SUNSHINE COAST REGIONAL DISTRICT STAFF REPORT

TO: Planning and Community Development Committee – July 15, 2021

SUBJECT: FORESTRY REFERRALS: BC TIMBER SALES (CRN00127), SUNSHINE COAST COMMUNITY FOREST (CRN00128)

Figure 1: Chapman Community Watershed, SCCF Block EW16

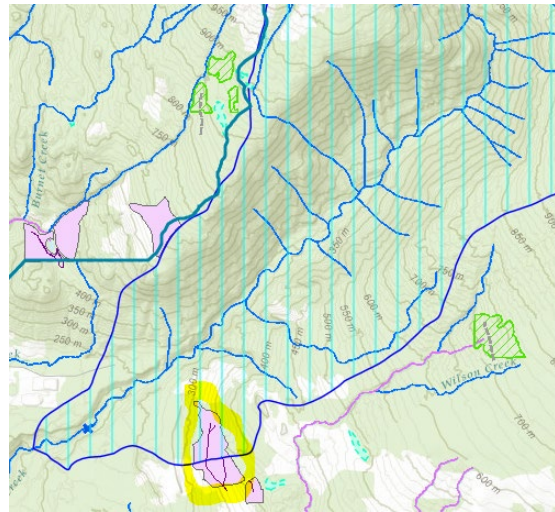
Staff understand SCCF is pursuing a watershed mapping amendment that could mean that this block is outside of the formal boundary. At the present time, it is located within.

SCR D does not support the harvest of the portion of the block EW16 that is within Chapman Community Watershed.

Figure 2: Gray Creek Community Watershed, SCCF Block AN20

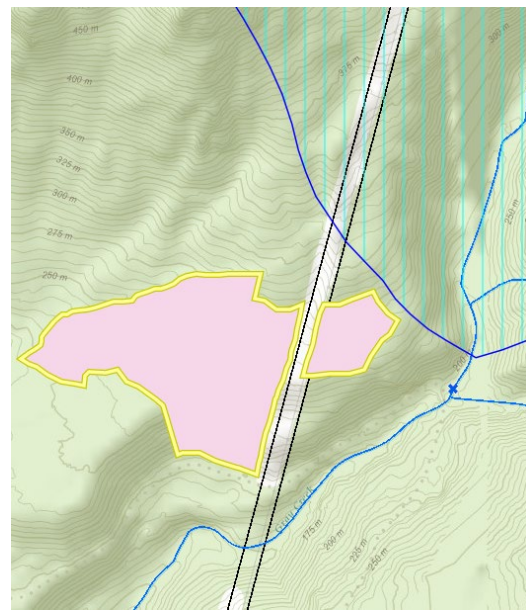
Staff note that the Province's spatial information appears to not include SCR D water intake in the Community Watershed area: note the blue hatch area as Community Watershed and the blue X as SCR D water intake infrastructure on the creek.

Proposed cut block AN20 is upslope of SCR D water intake infrastructure, with a steep slope in between. SCCF has proactively conducted a hydrological assessment that does not foresee sedimentation impacts.

While AN20 is outside of the Community Watershed, SCR D remains concerned about the proximity of this proposed harvesting to SCR D water supply. With a view to protecting natural assets, increasing climate resilience and employing the precautionary principle, SCR D does not support the harvest of AN20.

Staff have adapted previously adopted 2018 forestry referral response to address drinking water concerns that are located outside of the Community Watershed. If harvesting were to proceed for AN20, that SCR D request a clear limit of zero risk drinking water quality and quantity be established including:

- a. Define a drinking water protection strategy for proposed forestry operations that has the goal of achieving zero turbidity, zero sediment and zero pathogen input to nearby creeks or streams from forestry activities;
- b. Establish a monitoring and data sharing program.

Figure 3: Milne Community Watershed, SCCF Block AM50

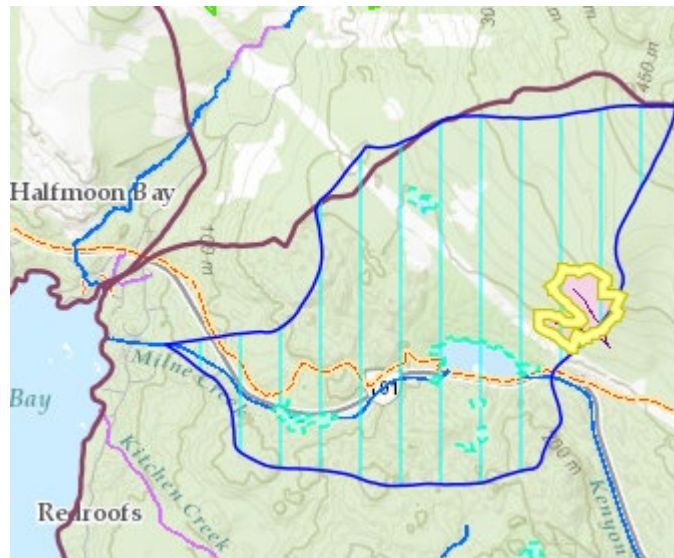
Proposed SCCF block HM50 is within Milne Watershed boundaries and upslope from Trout Lake.

The proposed block is also proximal to the proposed extension of Suncoaster Trail and several other community trails. If an alternate proposal is envisioned for this area, within proximity to Suncoaster Trail plans, SCR D recommends that SCCF consider block location and design after consultation with SCR D Parks staff.

SCR D does not support the proposed cutblock HM50 in Milne Community Watershed.

Figure 4: BCTS proposed blocks (light green) on Mount Elphinstone, with aquifer recharge zone light blue outline.

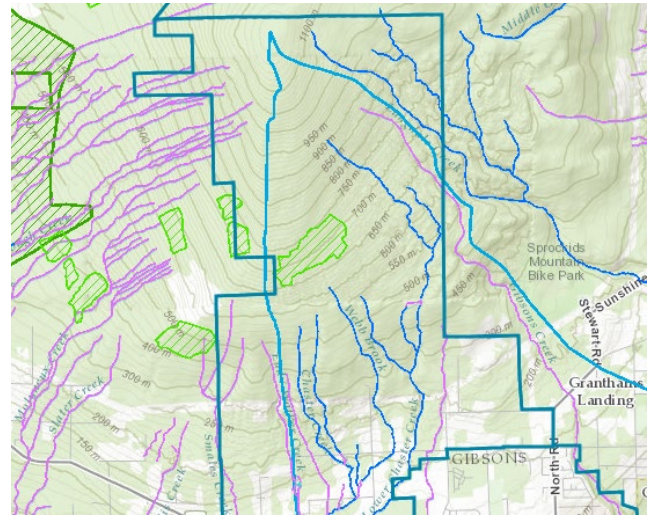
BCTS block G043B4P2 (highlighted in yellow) adds to the density of previously referred blocks on the steep areas of Mount Elphinstone, located above the Gibsons Aquifer, a community drinking water source.

Further to 2020 recommendations, SCRD does not support the harvest of G043B4P2 on Mount Elphinstone slopes in the Gibsons aquifer recharge area.

Dakota Community Watershed

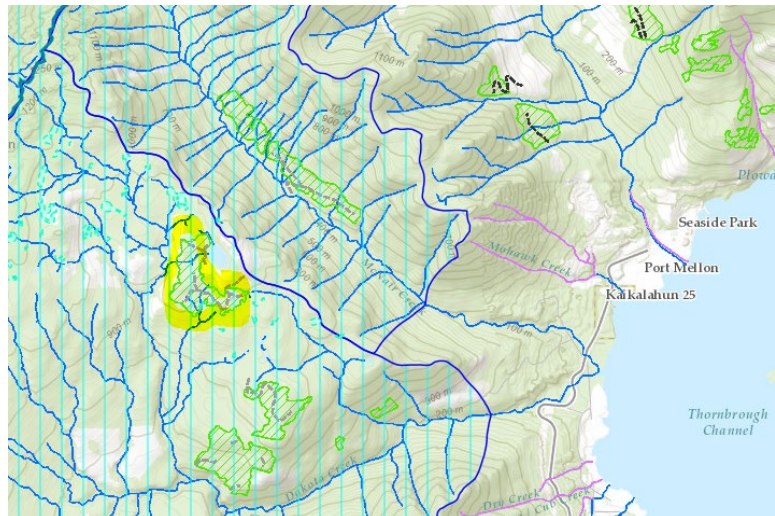
Dakota Community Watershed is identified by the Province as serving community for drinking water. The licenses are not related to the current SCRD water service provision. As they are identified community watersheds, SCRD does not support logging block G053C42X.

Policy 8.2.5: Elphinstone
Provincial Park (pg. 37)

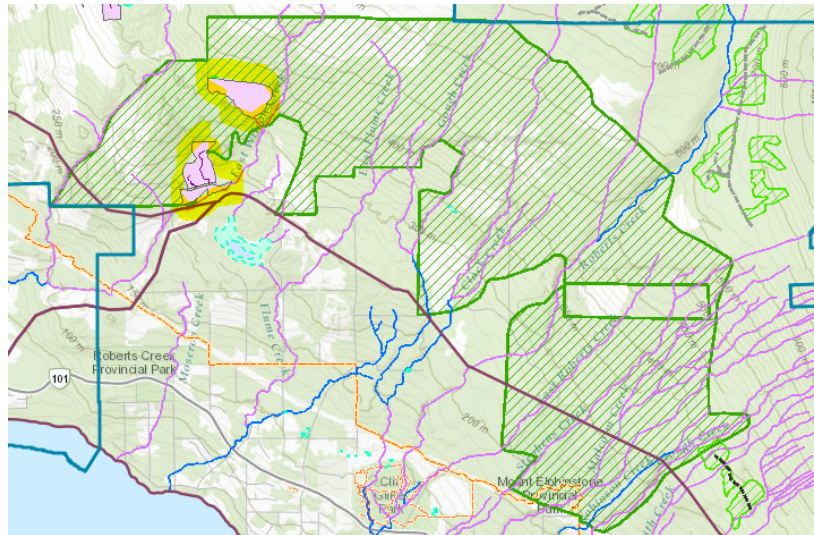
The dark green hatch area is the proposed future Elphinstone Provincial Park. The 3 purple blocks are proposed by SCCF. The proposal to log here contravenes the community's vision and objectives to the see the policy 8.2.5.
